HAMBLEN COUNTY LEGISLATIVE BODY

Regularly Scheduled Monthly Meeting
Thursday, October 19, 2023
5:00 p.m.

Project Name	Arch Project No.	Date
Hamblen County Justice Center	**590418**	**3/8/2023**
Subject	Specification No.	Drawing No.
RFI-204 and RFI-204.1 Exit Sign Deletions Day Rooms	**NA**	E2.1A.1, E2.1AM.1, E2.1B.1, E2.1BM.1, E2.2A.1, E2.2AM.1, E2.2B.1, E2.2BM.1, E2.3A.1, E2.3B1, AA5.1.7, A6.1.5.

FLOOR PLAN - LEVEL 2M - PART B - LIGHTING

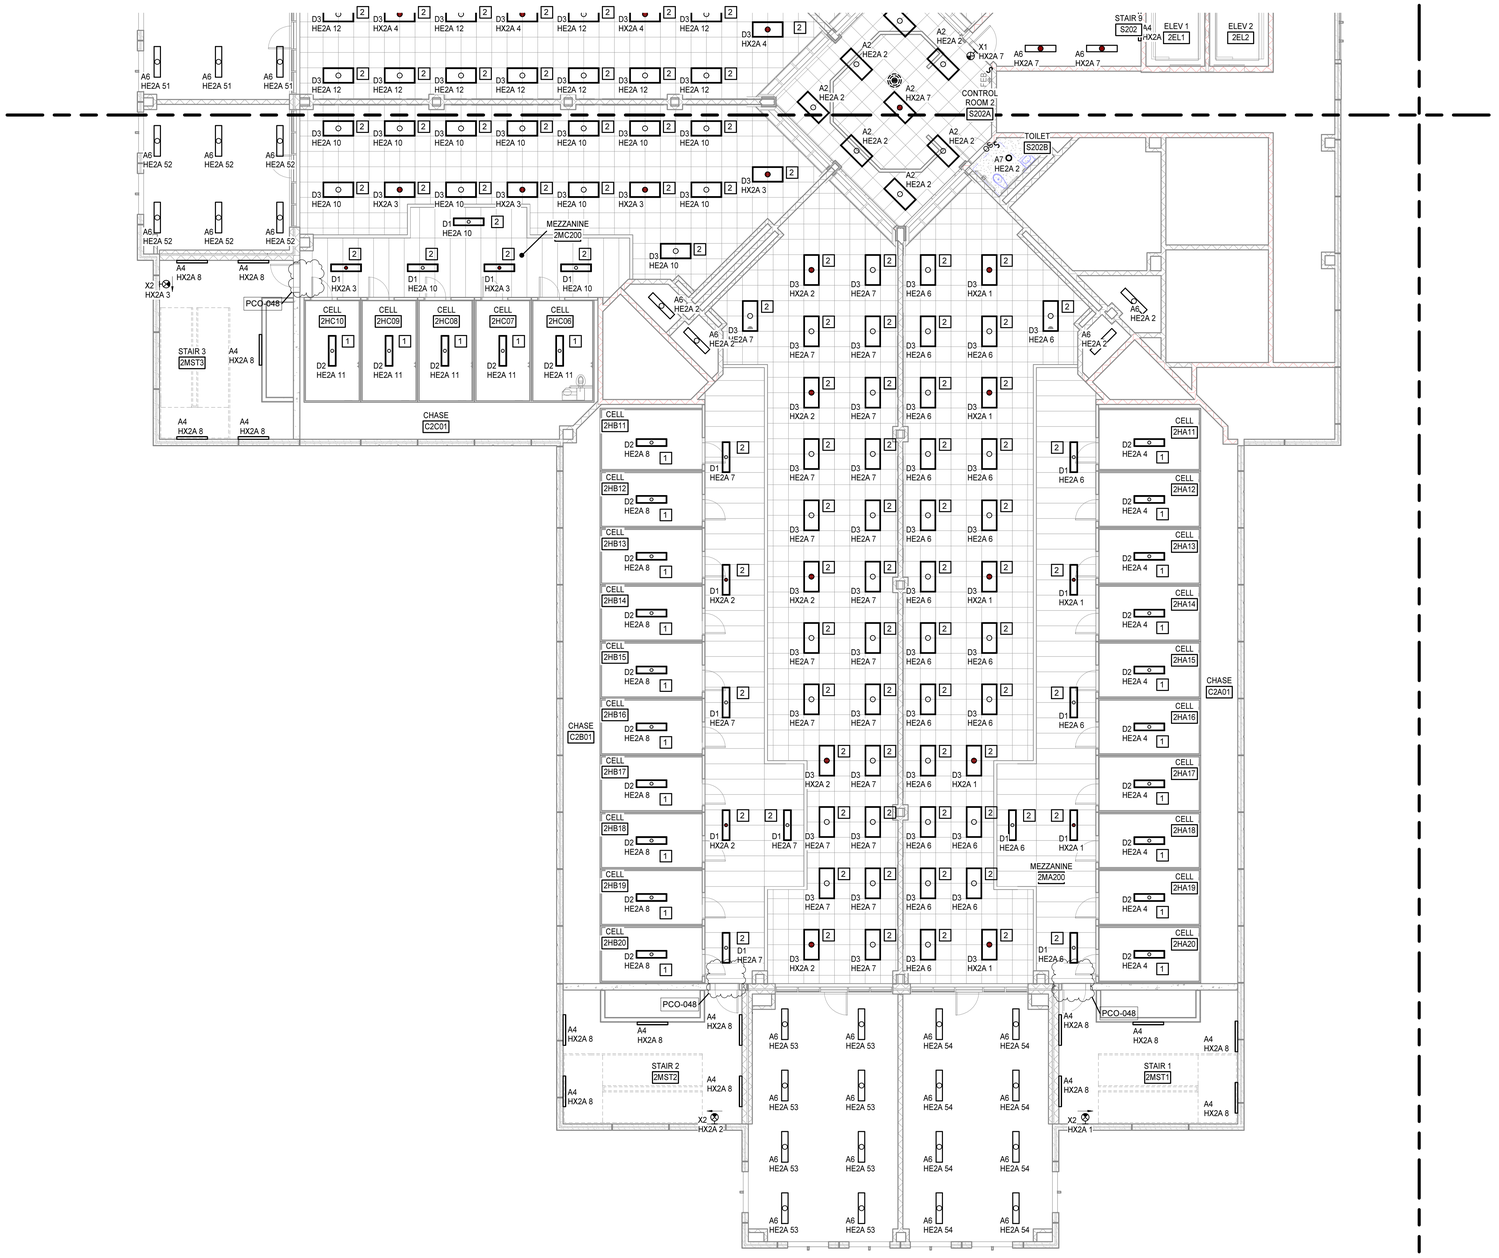
Please refer to updated drawings E2.1A.1, E2.1AM.1, E2.1B.1, E2.1BM.1, E2.2A.1, E2.2AM.1, E2.2B.1, E2.2BM.1, E2.3A.1, E2.3B1, AA5.1.7 and A6.1.5. These have been updated in response to RFI-204 and RFI-204.1. As discussed exit signs are not required in the day rooms. These updated drawings have been sent to state of TN for review and have been approved. The architectural drawing updates relate to deleting the note to provide a soffit for sprinkler pipe. The plate under mezzanine had been lowered to accommodate this change. Contractor is requested to hold it as high as possible.

4 WALL SECTION
A2.2A A5.1.7 3/4" = 1'-0"

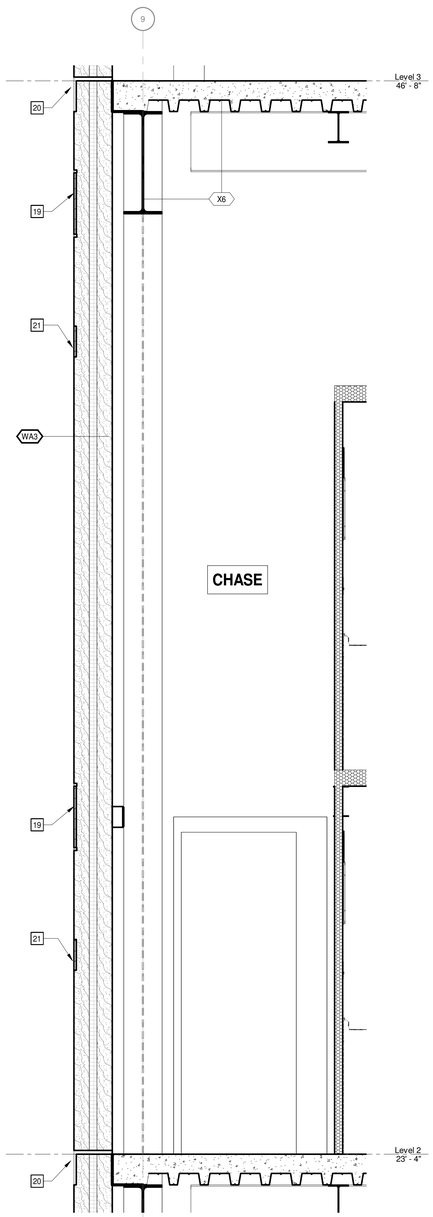
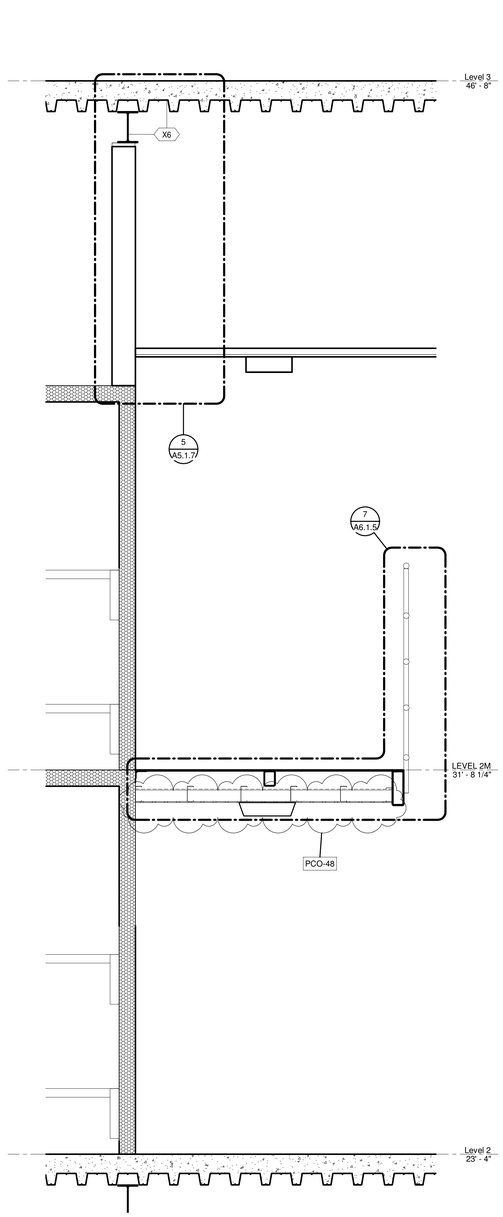
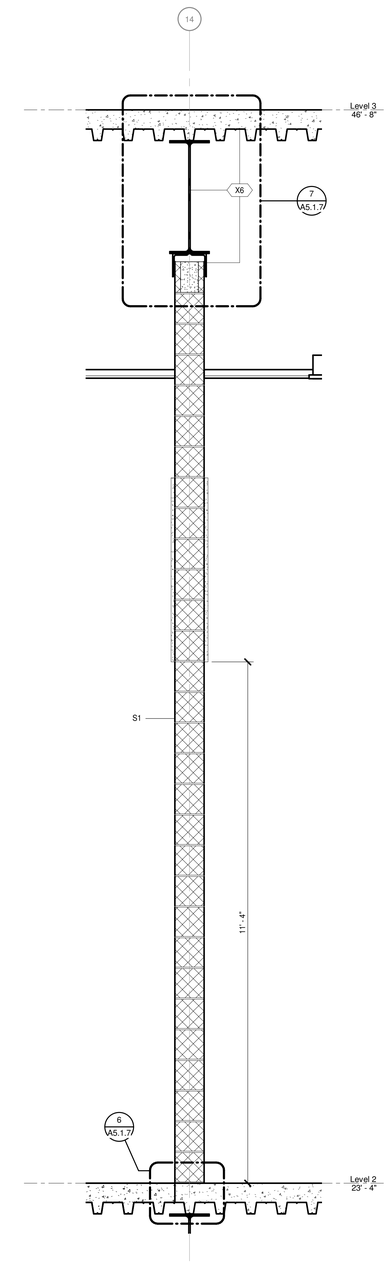
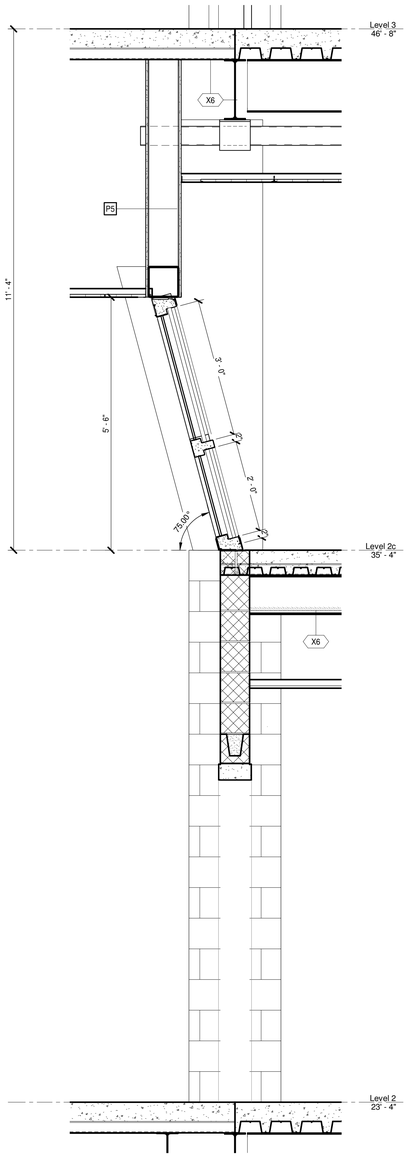
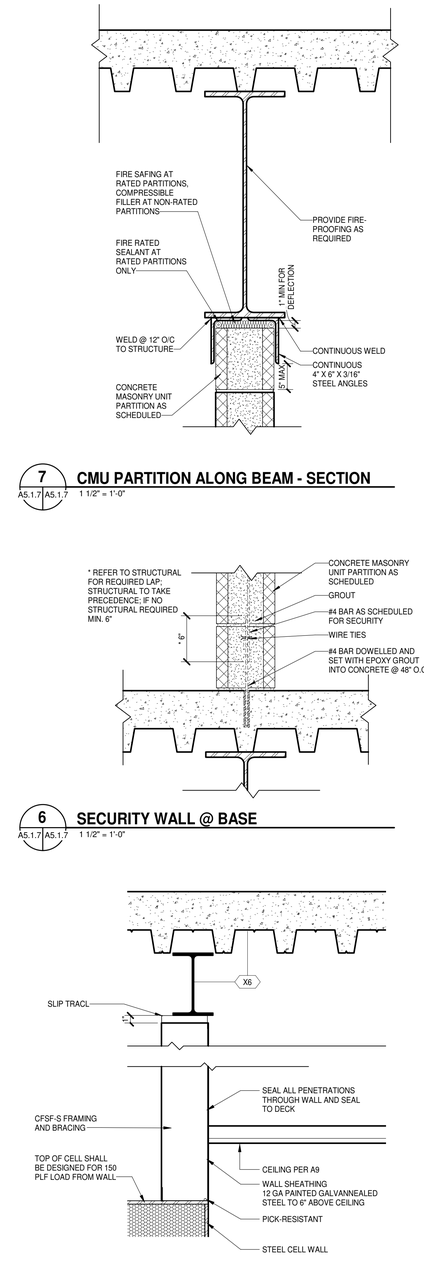
Project Name	Arch Project No.	Date
Hamblen County Justice Center	**590418**	**3/8/2023**
Subject	Specification No.	Drawing No.
RFI-204 and RFI-204.1 Exit Sign Deletions Day Rooms	**NA**	E2.1A.1, E2.1AM.1, E2.1B.1, E2.1BM.1, E2.2A.1, E2.2AM.1, E2.2B.1, E2.2BM.1, E2.3A.1, E2.3B1, AA5.1.7, A6.1.5.

Please refer to updated drawings E2.1A.1, E2.1AM.1, E2.1B.1, E2.1BM.1, E2.2A.1, E2.2AM.1, E2.2B.1, E2.2BM.1, E2.3A.1, E2.3B1, AA5.1.7 and A6.1.5. These have been updated in response to RFI-204 and RFI-204.1. As discussed exit signs are not required in the day rooms. These updated drawings have been sent to state of TN for review and have been approved. The architectural drawing updates relate to deleting the note to provide a soffit for sprinkler pipe. The plate under mezzanine had been lowered to accommodate this change. Contractor is requested to hold it as high as possible.

1 SITE PLAN - ELECTRICAL

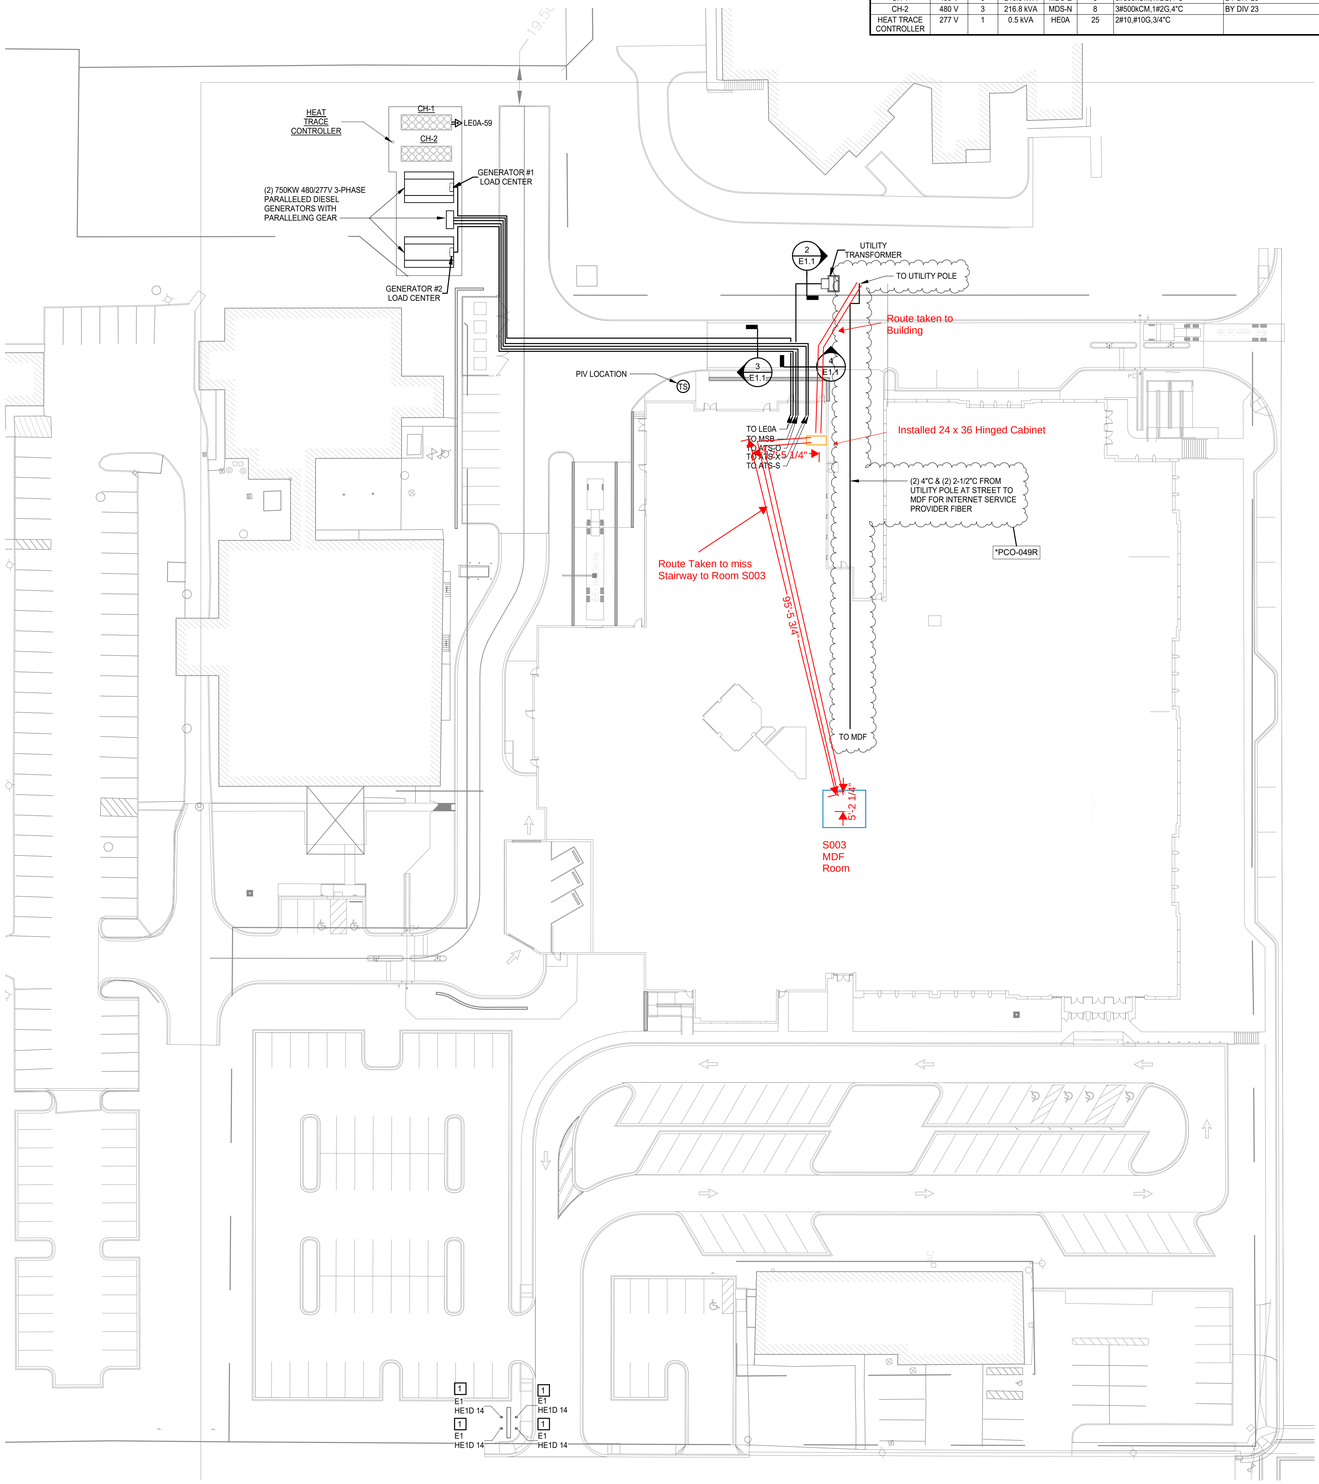
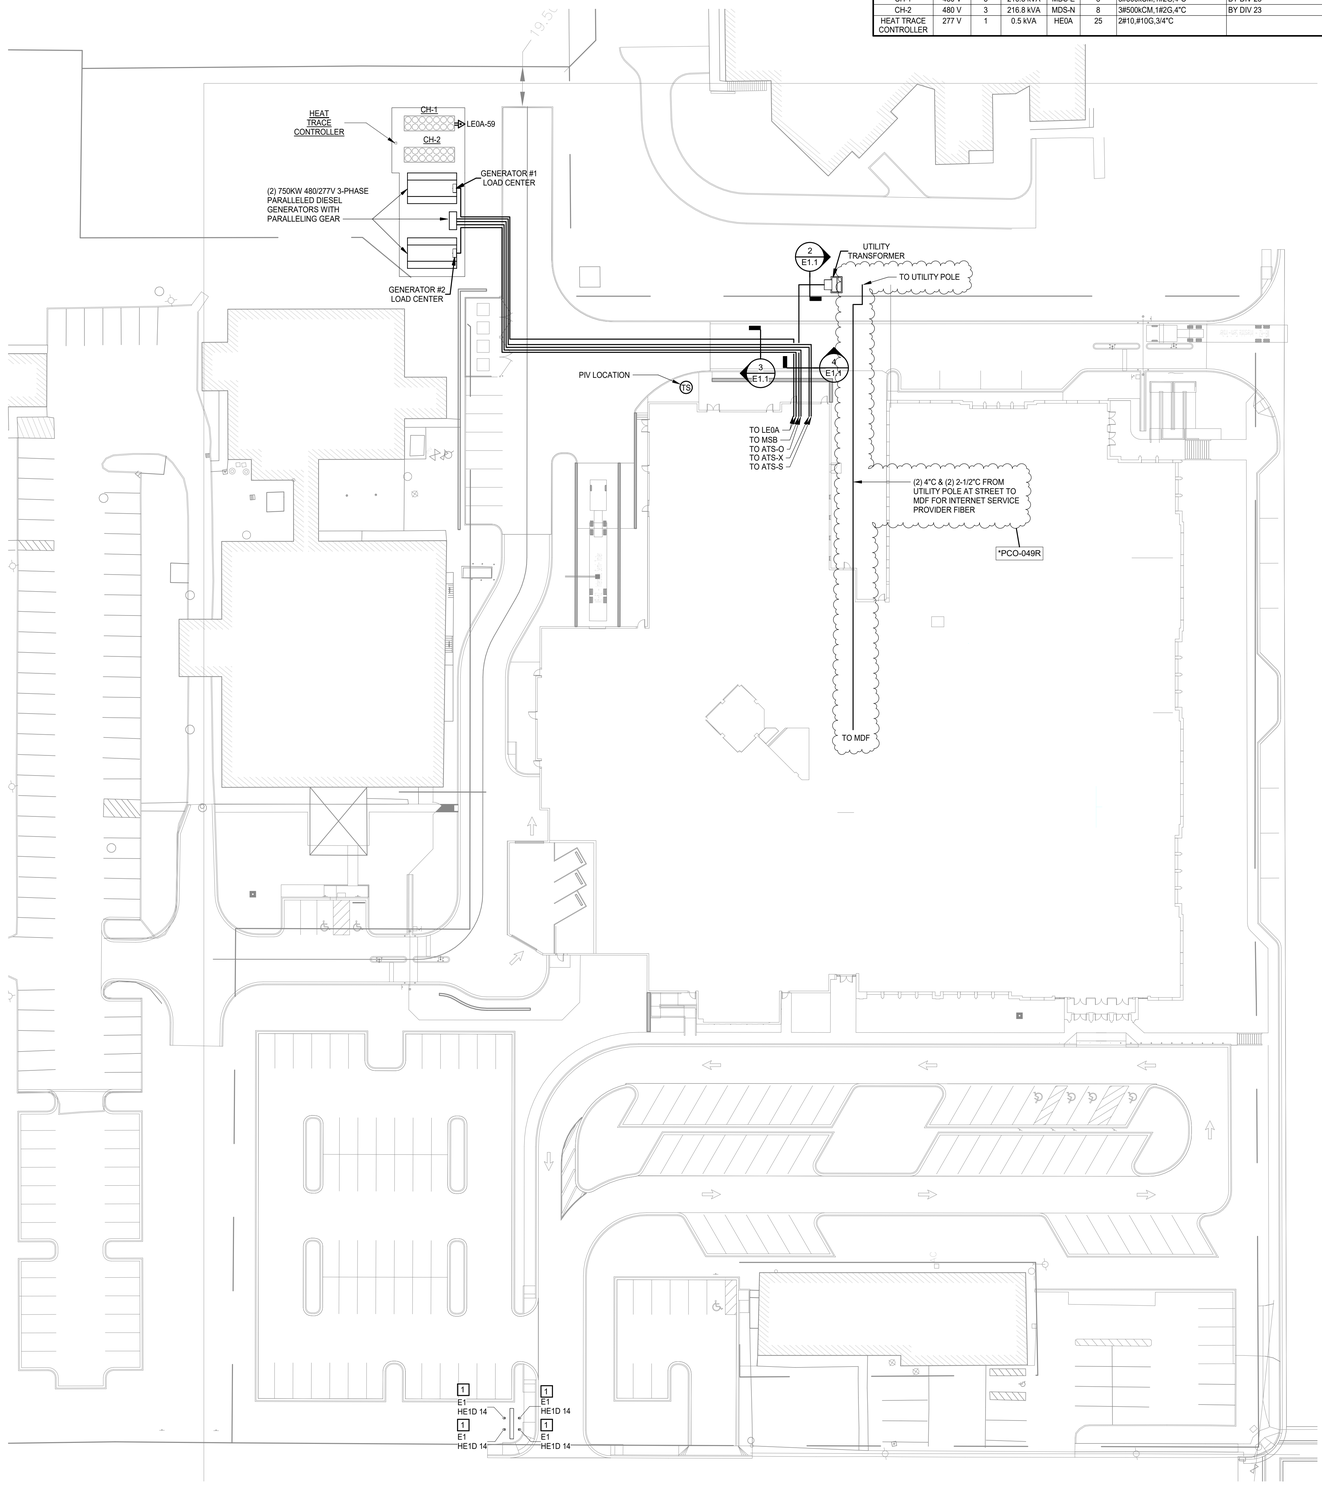
Project Name	Arch Project No.	Date
Hamblen County Justice Center	**590418**	**4/19/2023**
Subject	Specification No.	Drawing No.
Communications	**NA**	**E1.1**

Please refer to updated drawing E1.1 showing coordination for underground conduit indicated in original PCO-049 to turn up at the utility pole closest to the transformer.

A WATER SERVICE ENTRANCE DETAIL

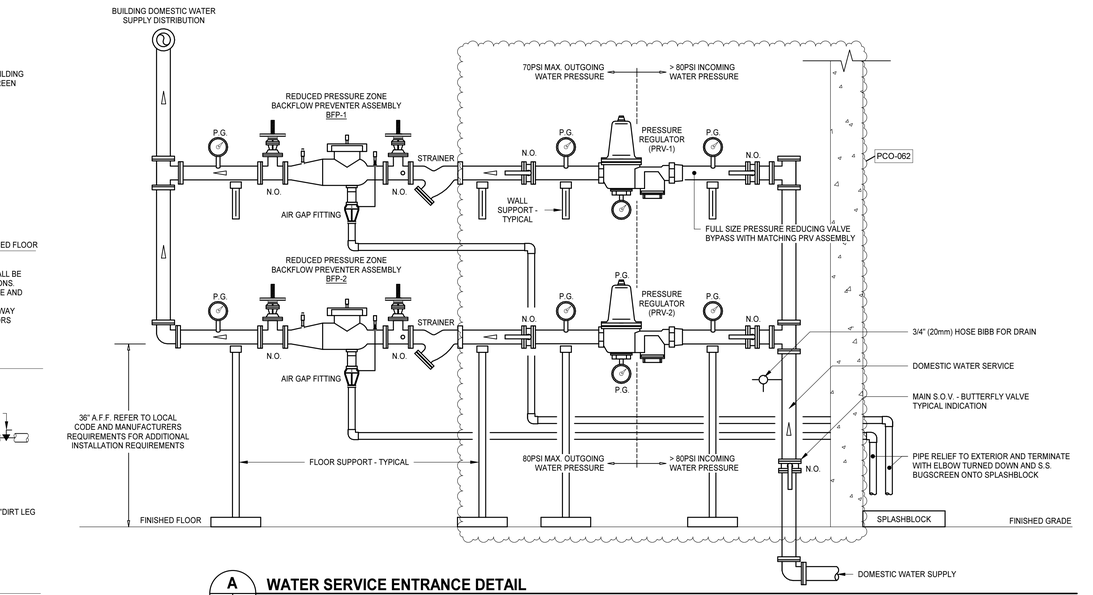
Project Name	Arch Project No.	Date
Hamblen County Justice Center	**590418**	**8/22/2023**
Subject	Specification No.	Drawing No.
Added Pressure Reducing Valve Domestic Water	**NA**	**P5.1 and P6.1**

Description: Please refer to updated drawings P5.1 and P6.1 indicating adding a Pressure Reducing Valve on the incoming domestic water line based on reported PSI from the city.
Cut Sheet for Pressure Reducing Valve
